Addendum No. 1

RE: Contract # C204471
WBS # 45446.3.1
FEDERAL-AID NO. NHS-0421(072)
Wilkes County (U-5312)
US-421 FROM EAST OF NC-16 TO US-421 BUS.

The following revisions have been made to the Utility Construction Plans.

LOCATION: US 421 FROM NC 16 TO US 421 BUSINESS IN WILKESBORO
TYPE OF WORK: WATER AND SANITARY SEWER RELOCATION

PROJECT REFERENCE NO.	SHEET NO.
U-5312	UC-28
DESIGNED BY: B. CLAWSON	
DRAWN BY: R. MOSS	
CHECKED BY: B. CLAWSON	
APPROVED BY:	
REVIS: 5/9/23 11/2/23	MUNICIPAL ENGINEERING SERVICES COMPANY, PA.
P.O. BOX 97 GARNER, NC 27529 1919172-5393	
UTILITY CONSTRUCTION PLANS ONLY

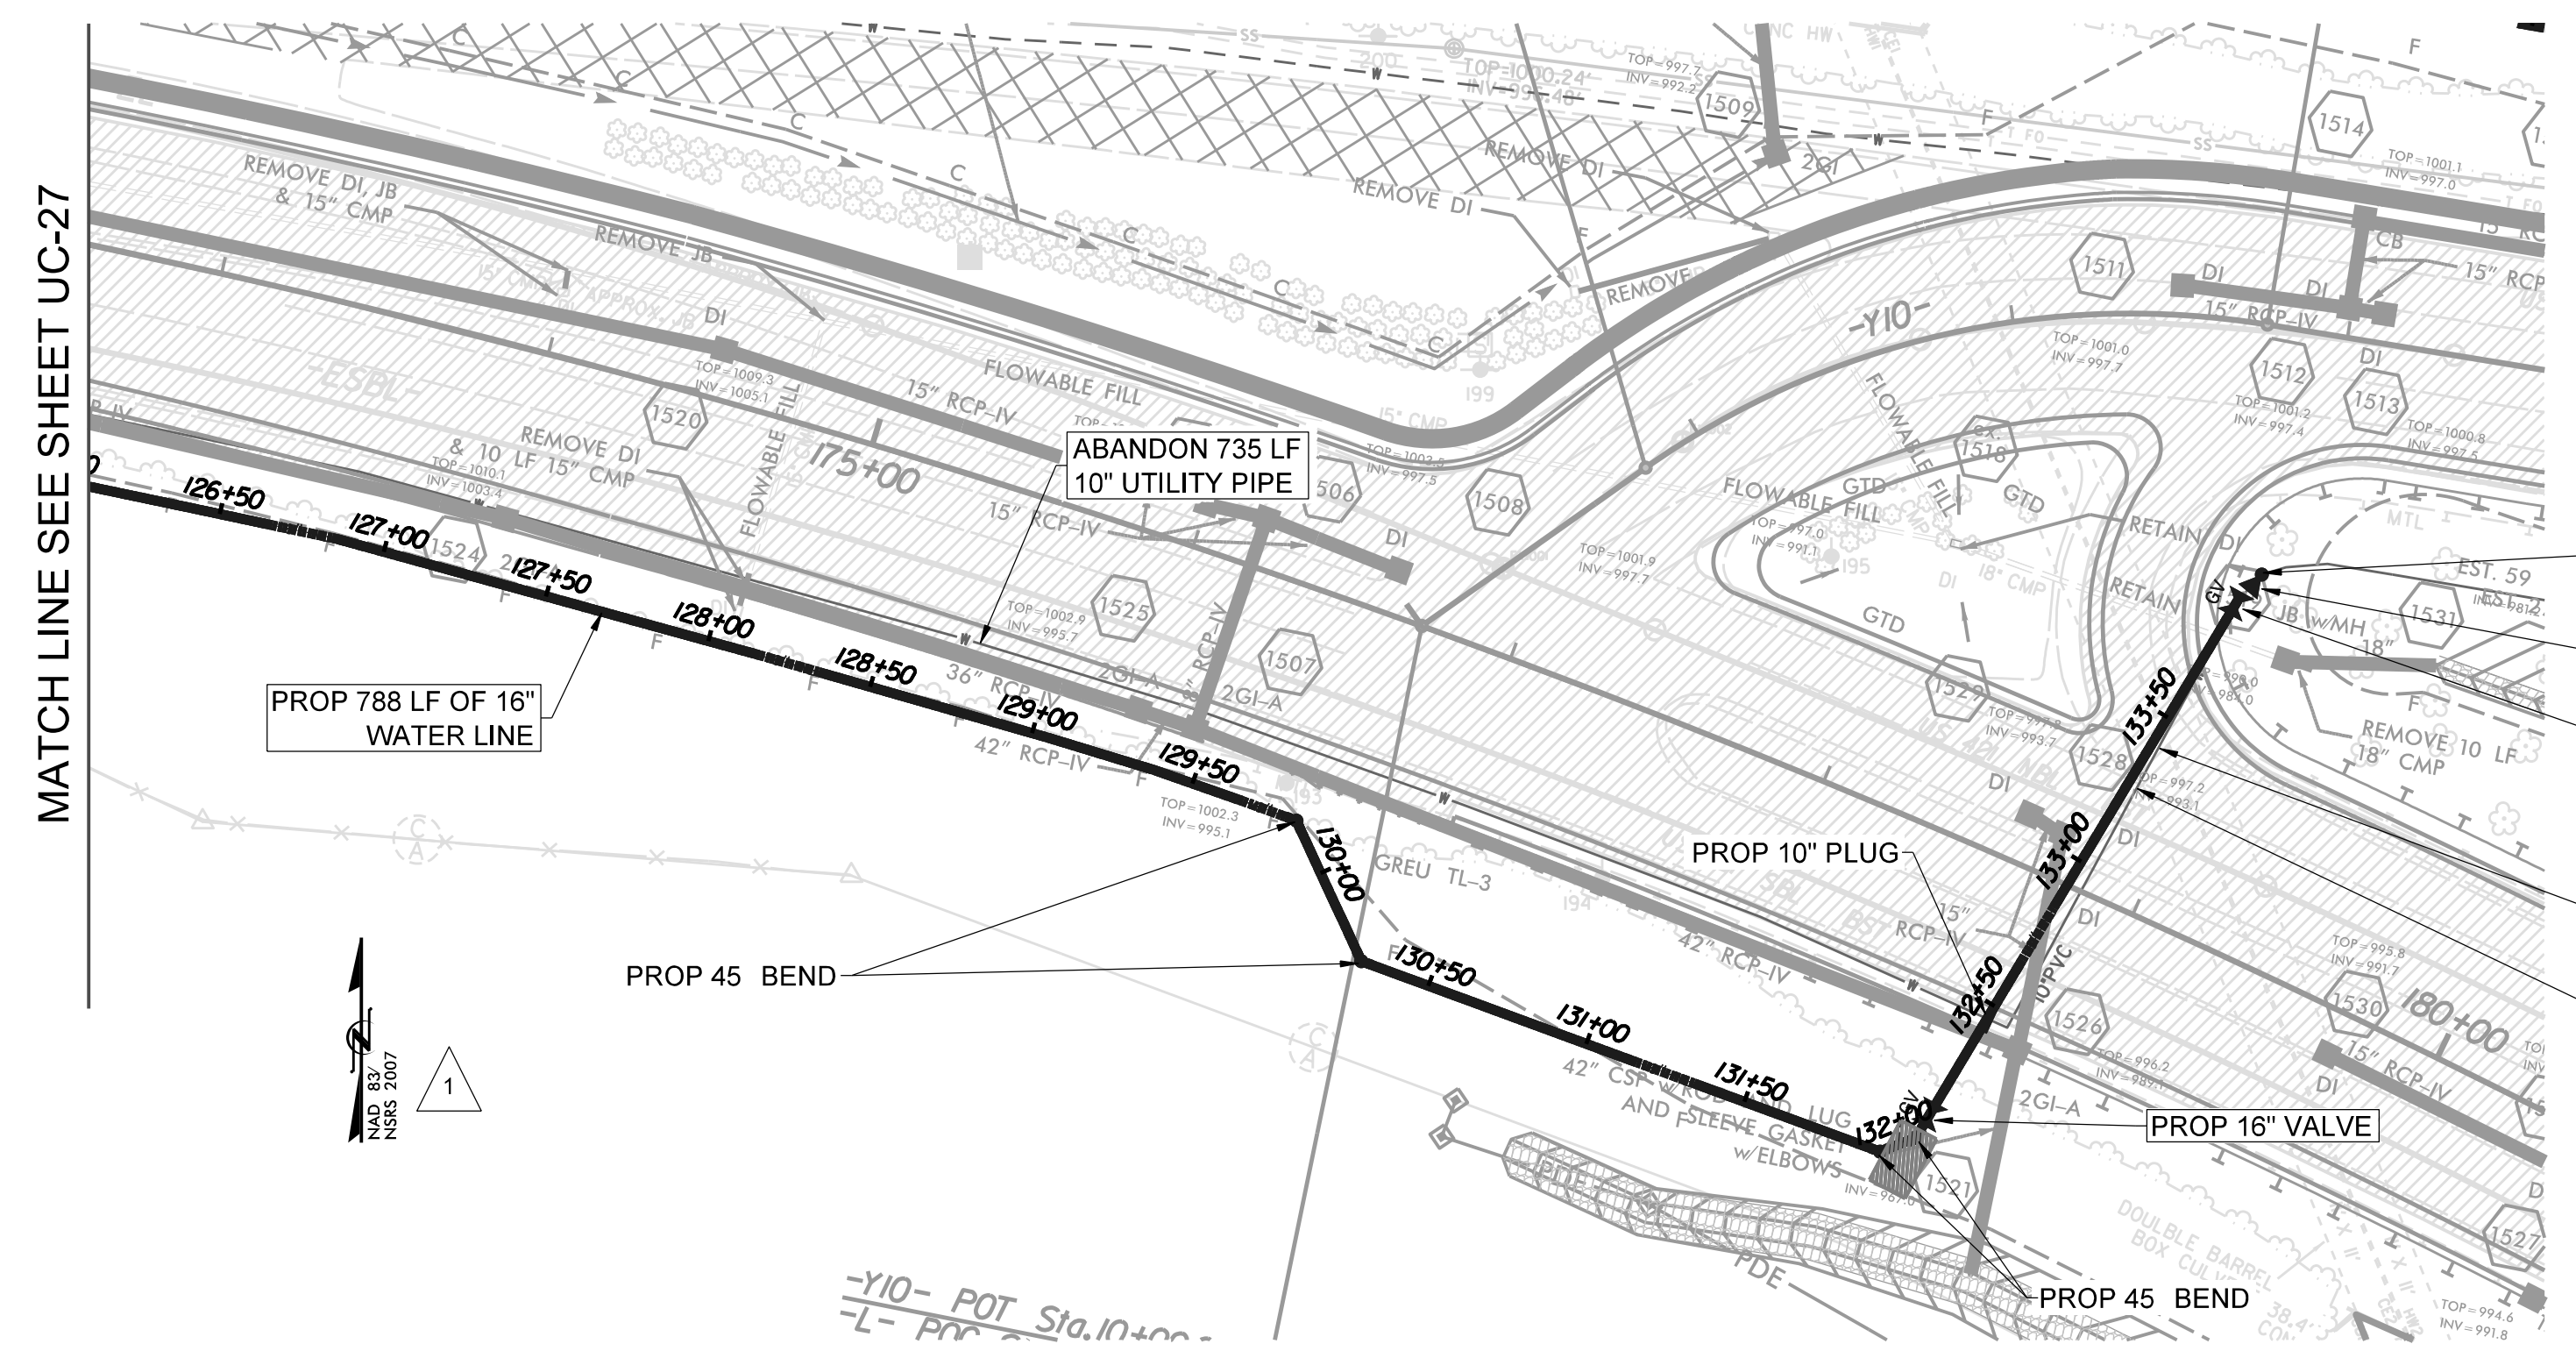
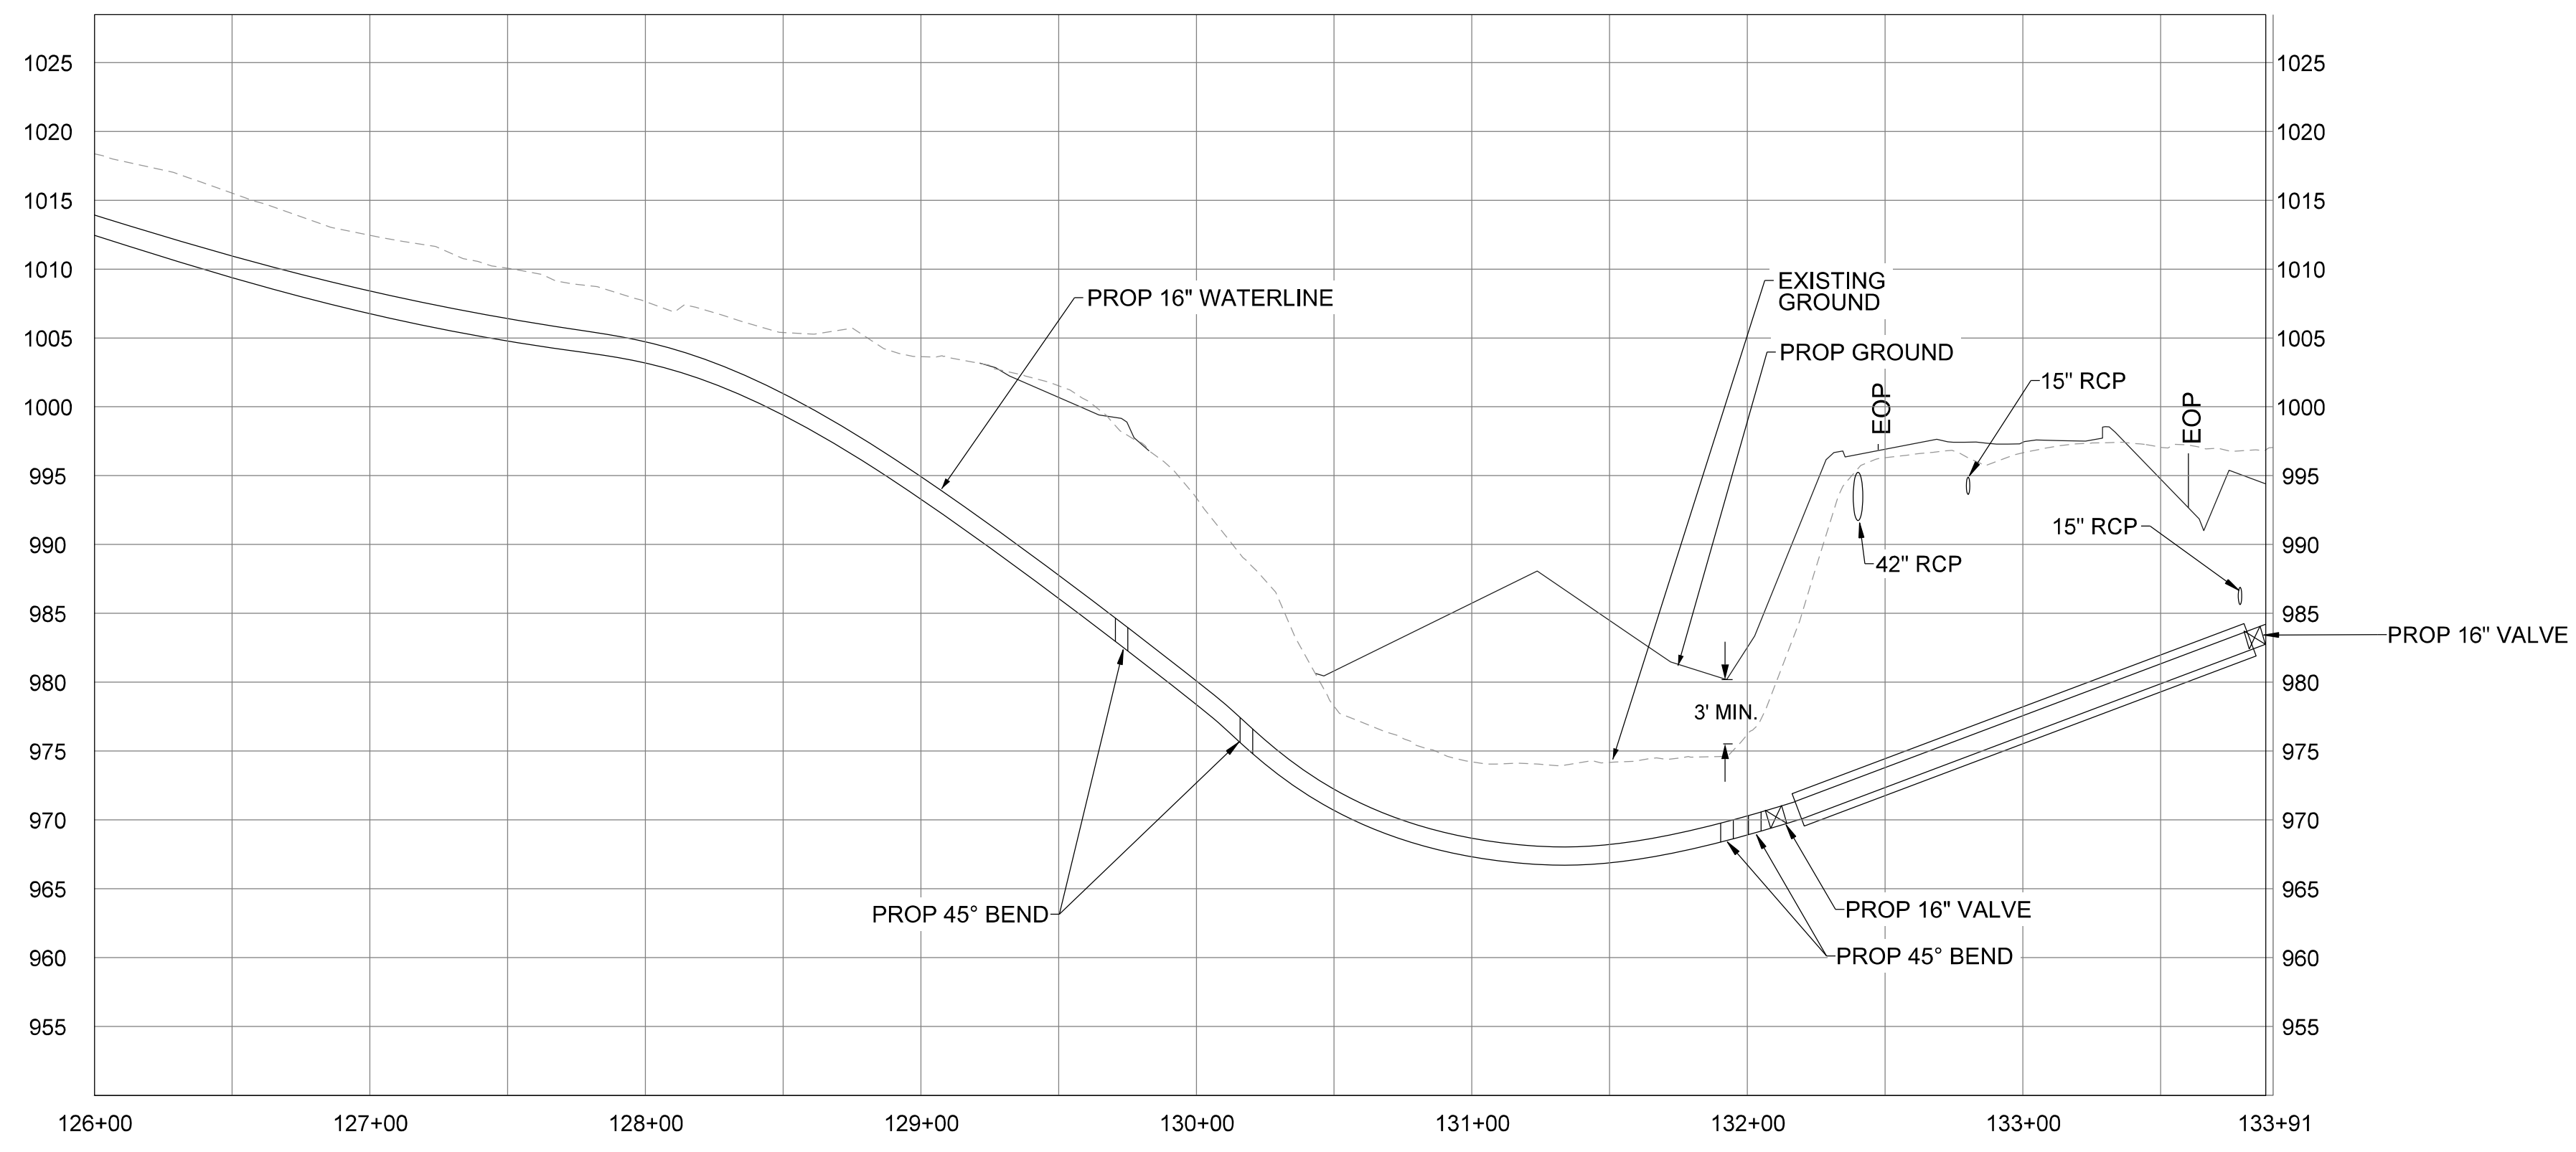
- 1 - ADDED NORTH ARROW
- 2 - ADDED LABELS IN PROFILE
- 3 - CHANGED NOTE #1

PROJECT REFERENCE NO.	U-5312	SHEET NO.	UC-29
DESIGNED BY:	B. CLAWSON		
DRAWN BY:	R. MOSS		
CHECKED BY:	B. CLAWSON		
APPROVED BY:			
REVISED:	5/9/23 11/2/23		
MUNICIPAL ENGINEERING SERVICES COMPANY, P.A.	P.O. BOX 97 GARNER, NC 27529 (919) 772-5393		
		UTILITY CONSTRUCTION PLANS ONLY

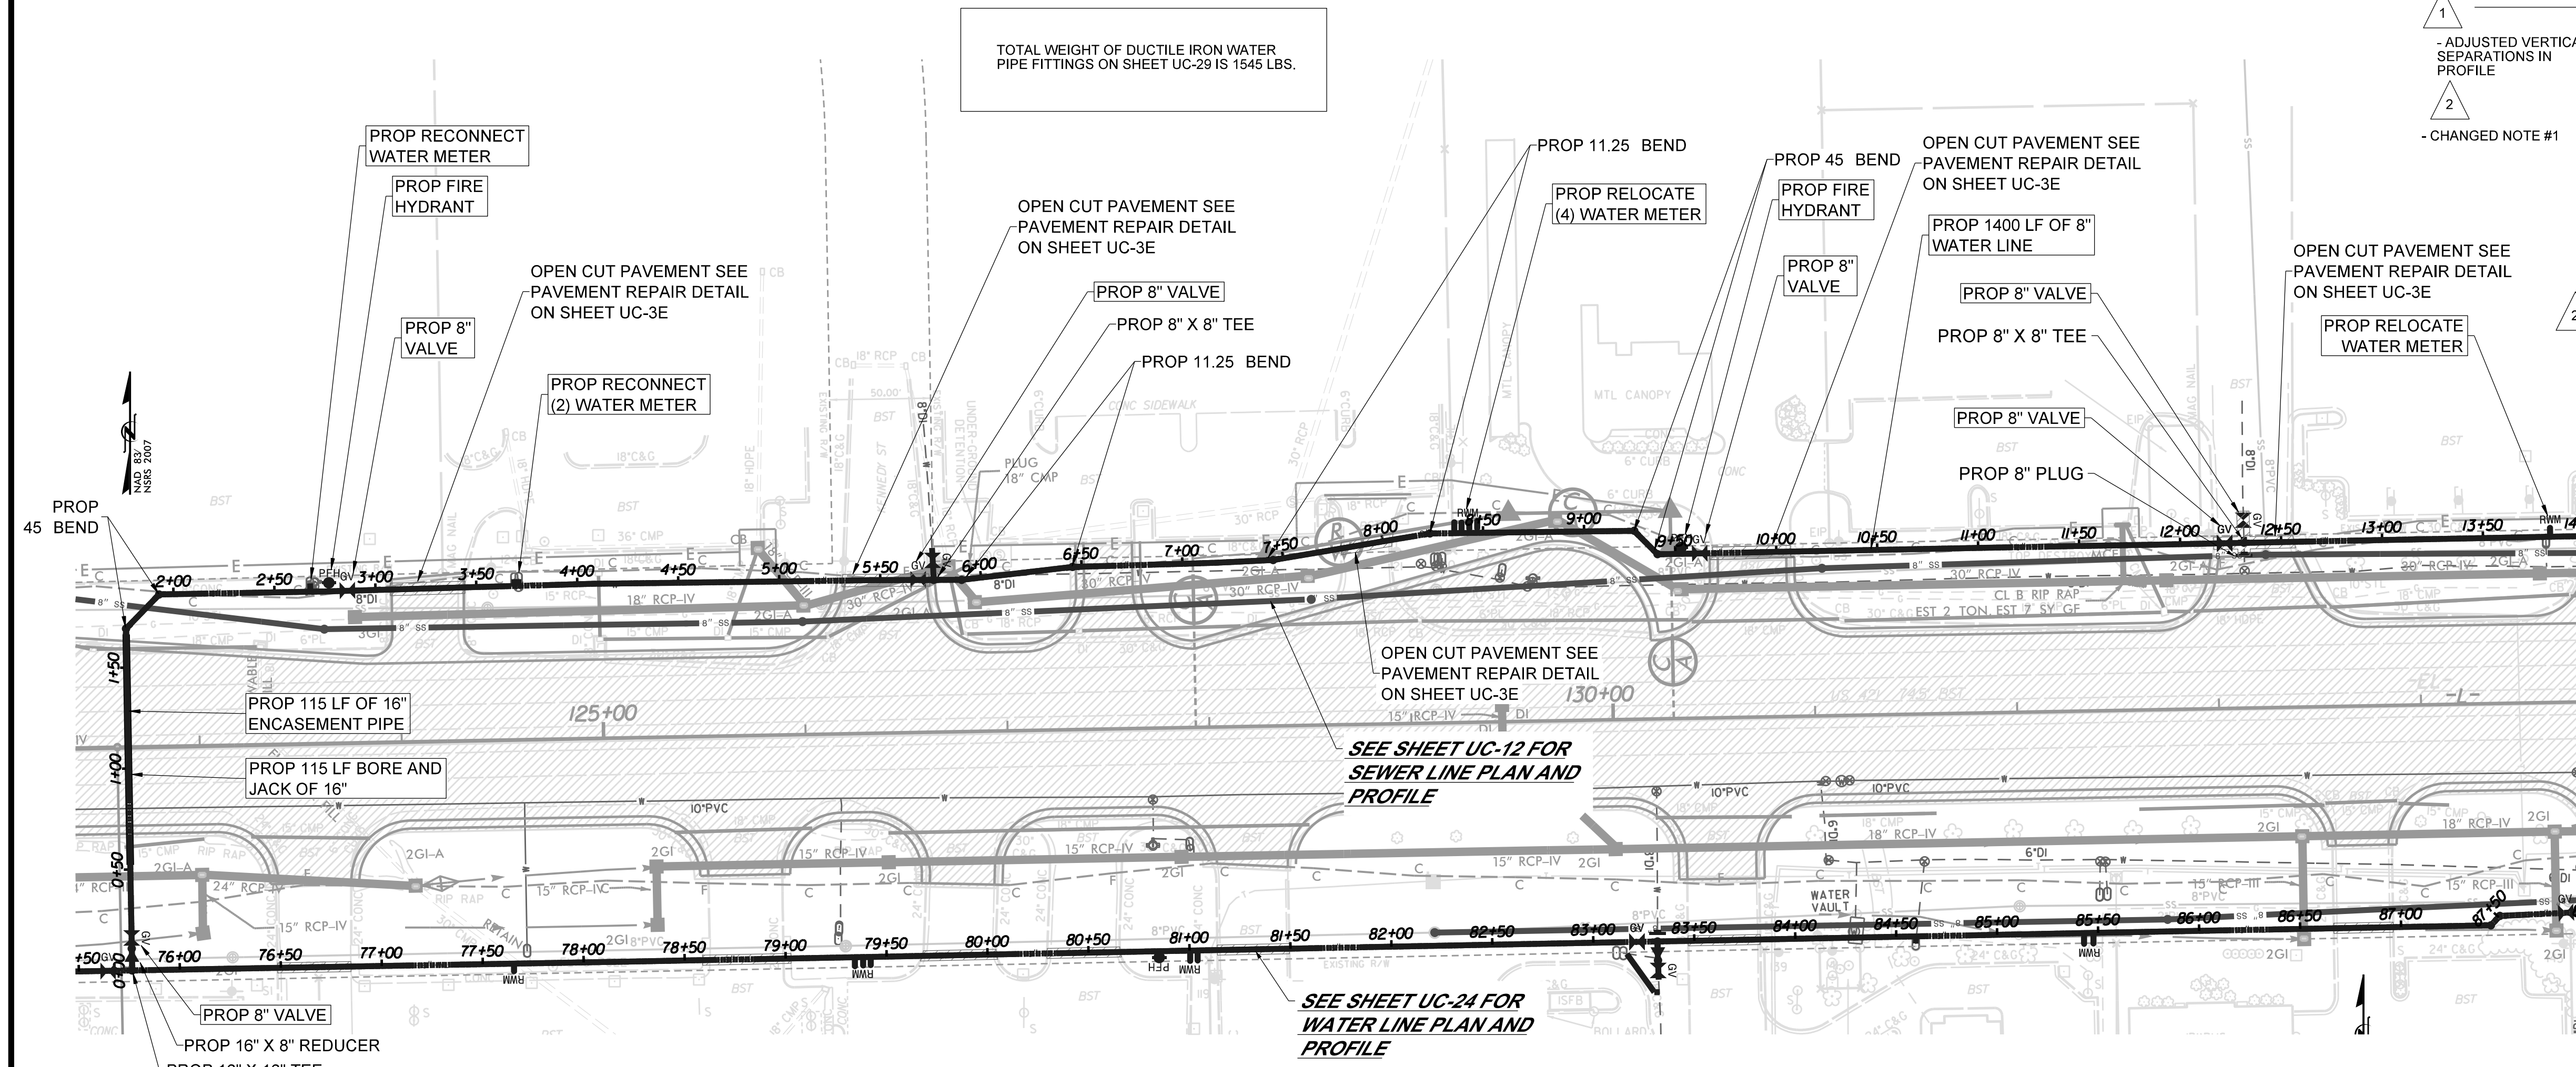
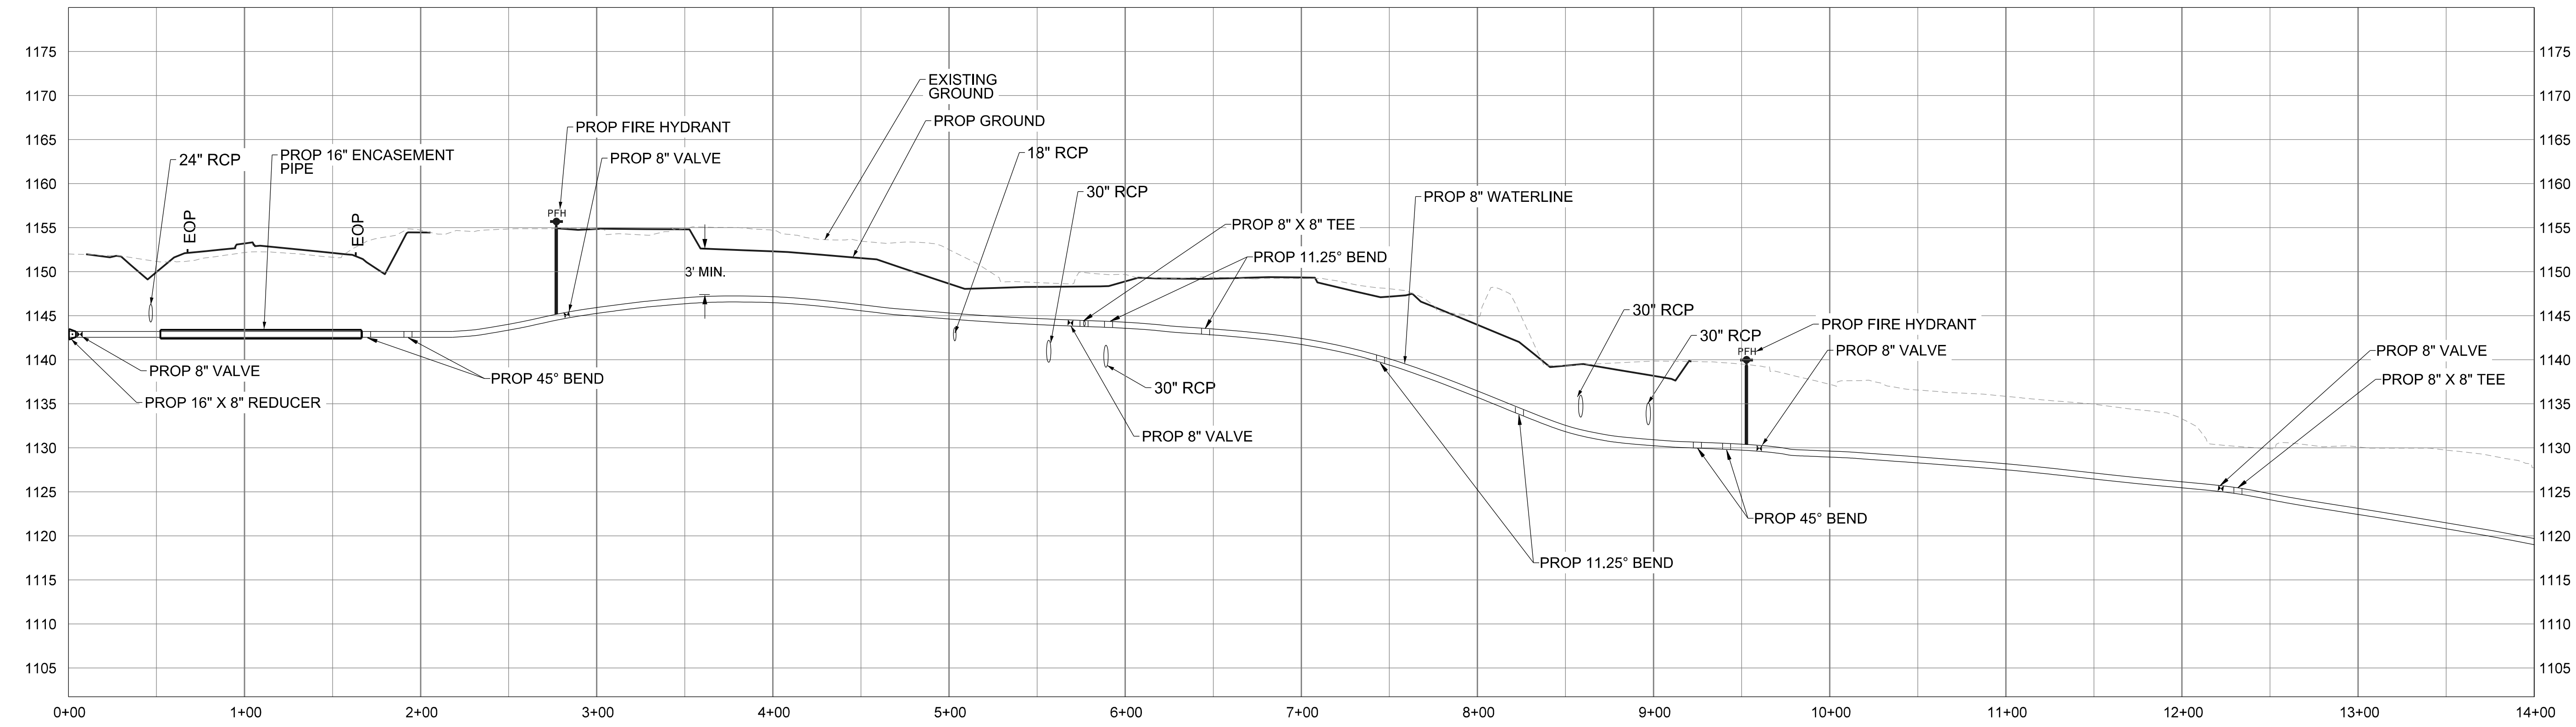
- 1 - ADJUSTED VERTICAL SEPARATIONS IN PROFILE
- 2 - CHANGED NOTE #1

- NOTES:
1. WATERLINE MATERIAL SHALL BE: DIP-CLASS 350 (ALL OPEN TRENCH INSTALLATIONS), HDPE-DR7 (DIRECTIONAL BORE INSTALLATIONS), COPPER (SERVICE INSTALLATIONS)
